ITEM 4.1: **Design Review Permit – 2081 Oak Meadow Drive – WRSP PCL F-31 – Goddard School
– File #PL21-0332**

The applicant requests approval of a Design Review Permit to allow the development of a 12,914-square-foot building for Goddard School (a childcare facility), with associated parking, lighting, landscaping, and outdoor playground.

Figure 2: Approved Plaza at Blue Oaks Site Plan

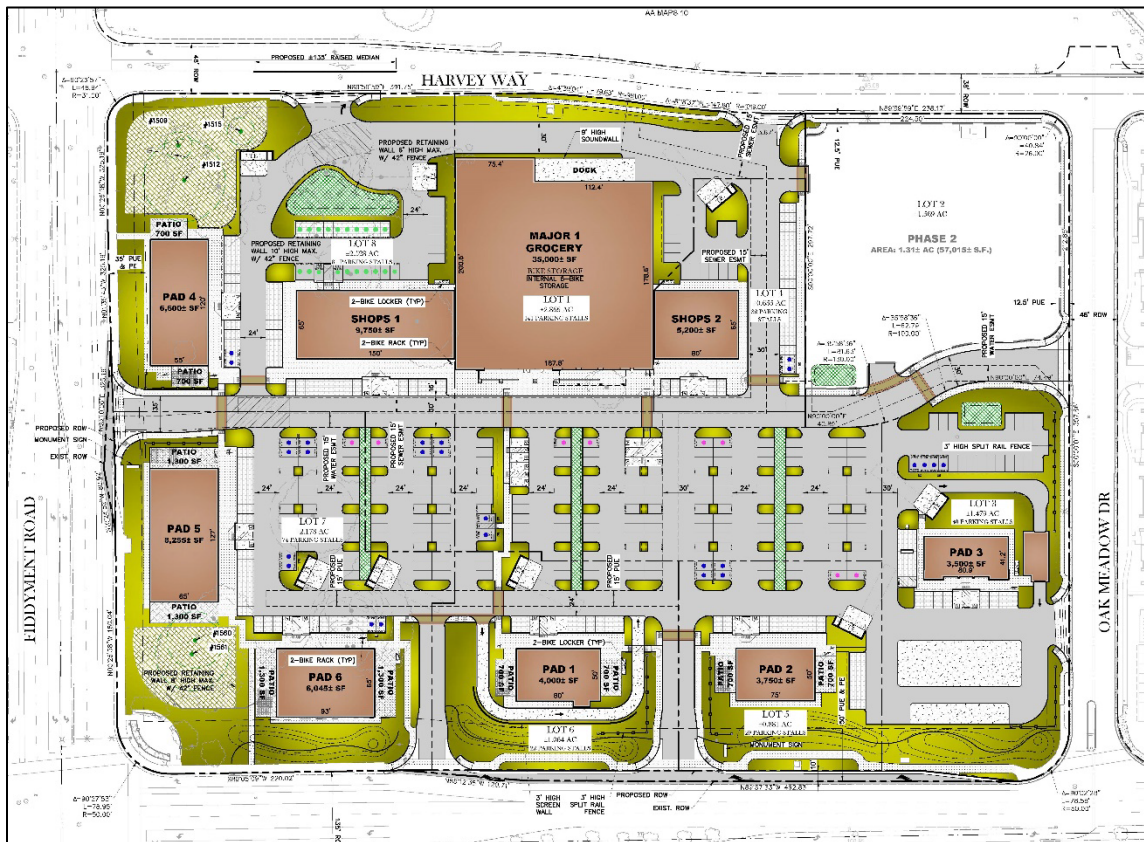
The proposed project is located on Lot 2 of the above site plan. No building was proposed on Lot 2 with the original DRP approval; however, it was anticipated for development at a later phase. The project is a request for a Design Review Permit to allow construction of a 12,914-square-foot building for Goddard School (a childcare facility), with associated parking, lighting, and landscaping (see Figure 3). The proposed childcare facility is classified as a day care use, which is a principally permitted use in the CC zone district and is consistent with the CC land use designation of the site. As proposed, the facility will have a total of 180 children from the ages of 6 weeks through 6 years old with a total of 24 staff members when the facility is at full capacity. The building will consist of 12 classrooms, a large multi-purpose room, offices, kitchen, restrooms, service rooms, and outdoor playground areas. The hours of operation will be from 7:00 a.m. to 6:00 p.m., Monday through Friday, with periodic special events occurring outside of normal operating hours.
